<b>DOCKETED</b>	
<b>Docket Number:</b>	18-IRP-01
<b>Project Title:</b>	Integrated Resource Plan
<b>TN #:</b>	228925
<b>Document Title:</b>	Staff Paper - Review of Pasadena Water and Power's 2019 Integrated Resource Plan
<b>Description:</b>	*** THIS DOCUMENT SUPERSEDES TN #227762 ***
<b>Filer:</b>	Harinder Kaur
<b>Organization:</b>	California Energy Commission
<b>Submitter Role:</b>	Commission Staff
<b>Submission Date:</b>	7/9/2019 3:04:02 PM
<b>Docketed Date:</b>	7/9/2019

# **Review of Pasadena Water and Power's 2019 Integrated Resource Plan**

April 2019 | CEC-200-2019-004

**Figure 1: Pasadena and Energy Commission Energy Forecasts 2019-2030 (GWh)**

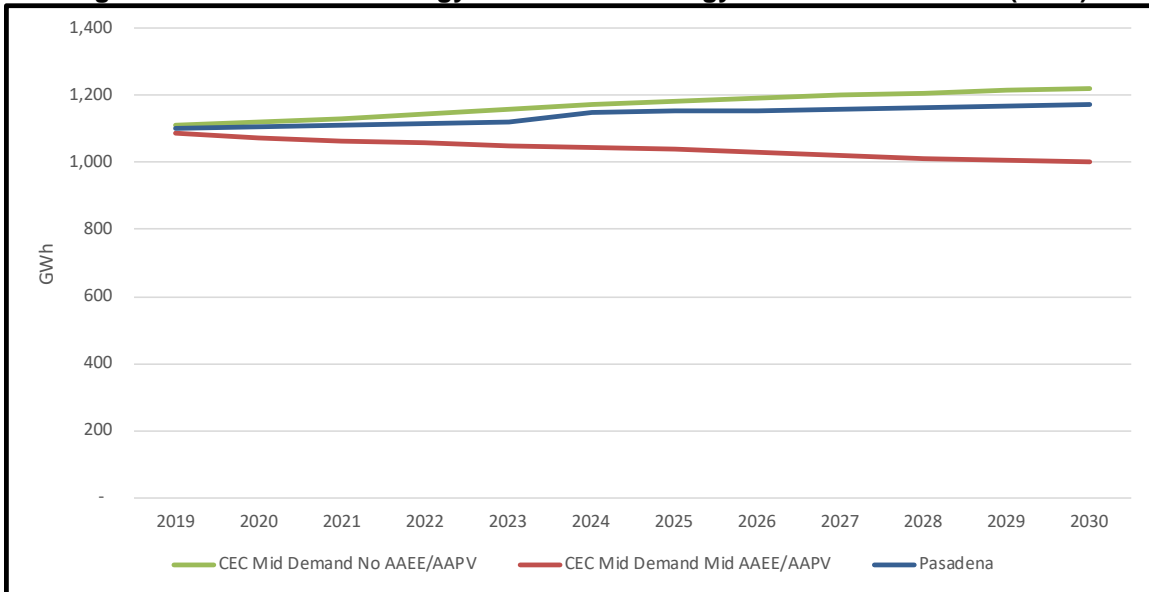
Differences in assumptions, data, and model specifications make it difficult to discern the reasons for differences between the long-term forecasts of energy and peak developed by Pasadena and the Energy Commission (**Figure 1** and **Figure 2.**) However, the treatment of PV in the forecasts may explain much of the difference. The green line (Energy Commission forecast), has no adjustments for energy efficiency savings or mandated PV system installation in new single-family homes constructed in the future. The red line (Energy Commission) accounts for future energy efficiency savings and reductions in electricity sales due to PV installations in new single-family homes. The blue line (Pasadena’s long-term energy forecast) is in the range of the Commission’s two mid-case scenarios. The utility’s long-term peak forecast is higher than the Commission’s forecast. This could be due to differences in historical weather data, weather normalization process, or model specifications. Pasadena’s forecast is suitable for long-term planning given the uncertainties during the planning period.
